SUBJECT: GATE PARKWAY TRAFFIC CALMING

BID #: CP-0081-21 **OPEN DATE:** 2021-05-05

Change Order No. Three (3) Date February 3, 2023

CHANGE ORDER BREAKDOWN
GATE PARKWAY TRAFFIC CALMING
CONTRACT NO. 71077-21

SHEET NO 6

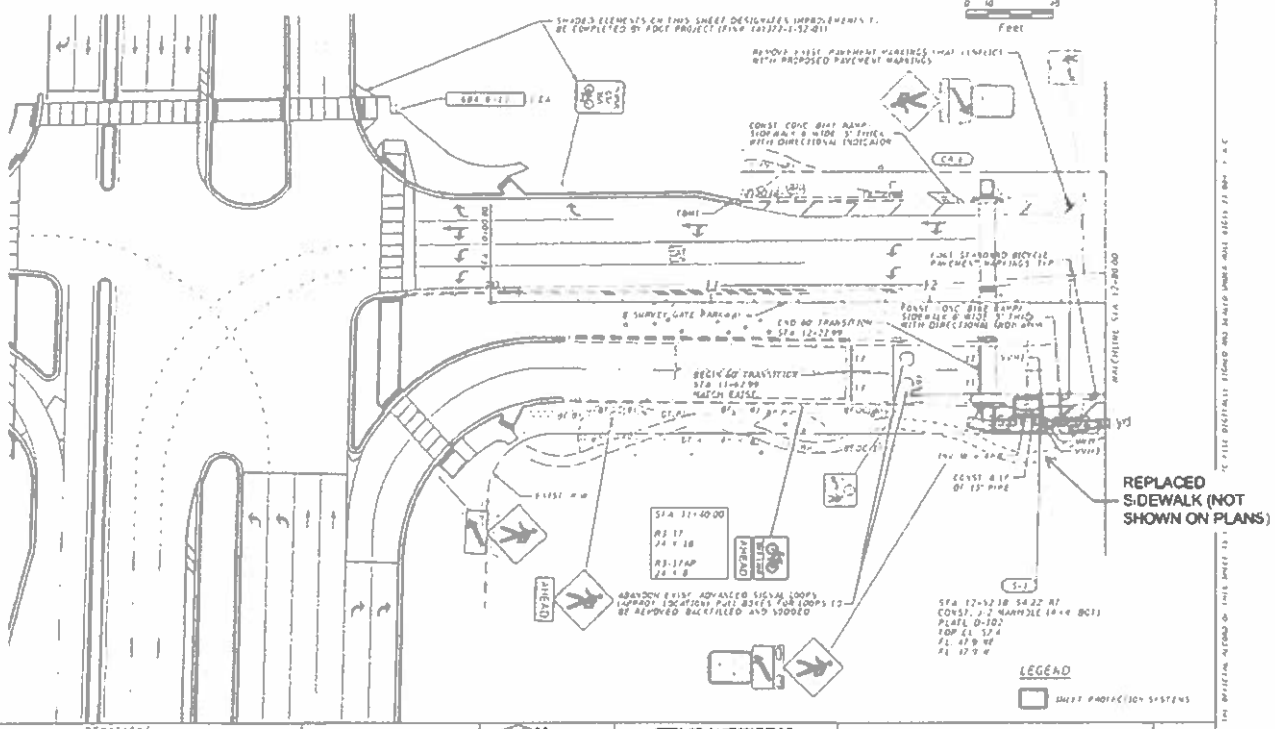
Change Request No. 13
Additional Concrete Sidewalk Replacement
from Structure S-1 to S-2

SHEET NO 7

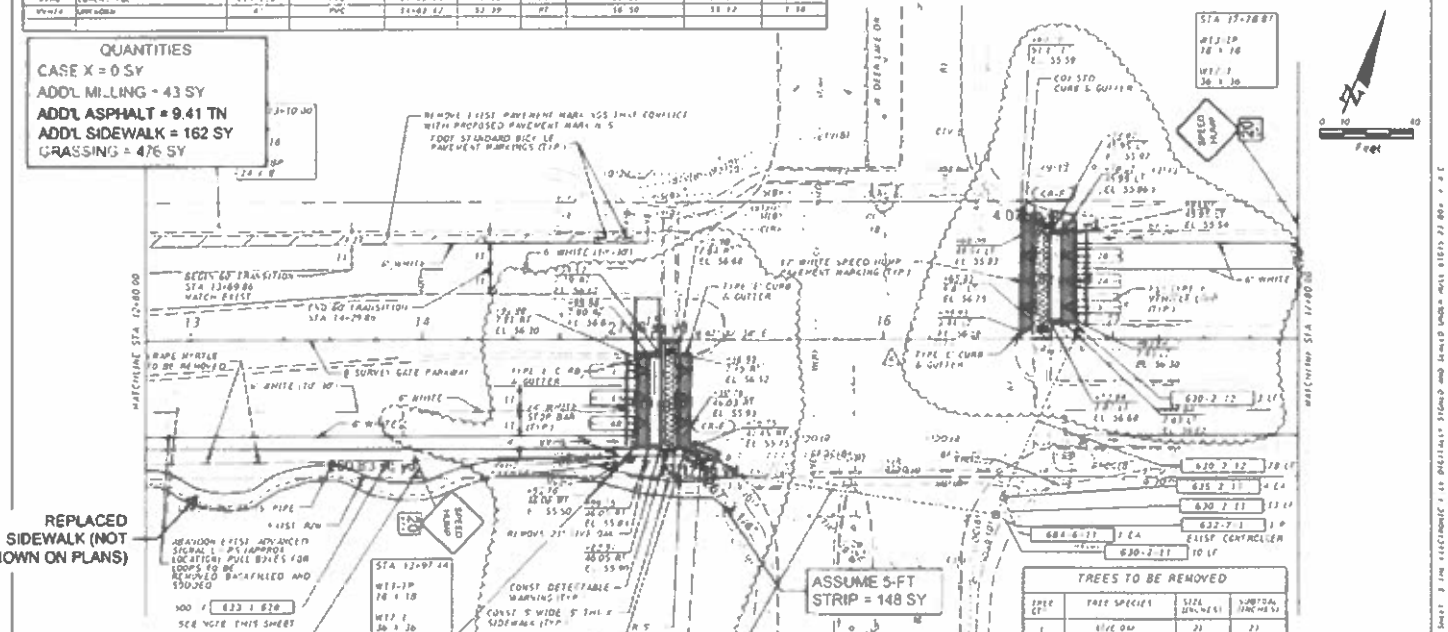
QUANTITIES
CASE X = 0 SY
ADD'L MILLING = 43 SY
ADD'L ASPHALT = 9.41 TN
ADD'L SIDEWALK = 162 SY
GRASSING = 476 SY

REVISIONS			
DATE	DESCRIPTION	DATE	DESCRIPTION
3/3/23	1 REVISION TO INCLUDE REMOVAL OF 12" MAGNOLIA TREE		
9/19/22	1 TABLE TOP ADJUSTMENTS
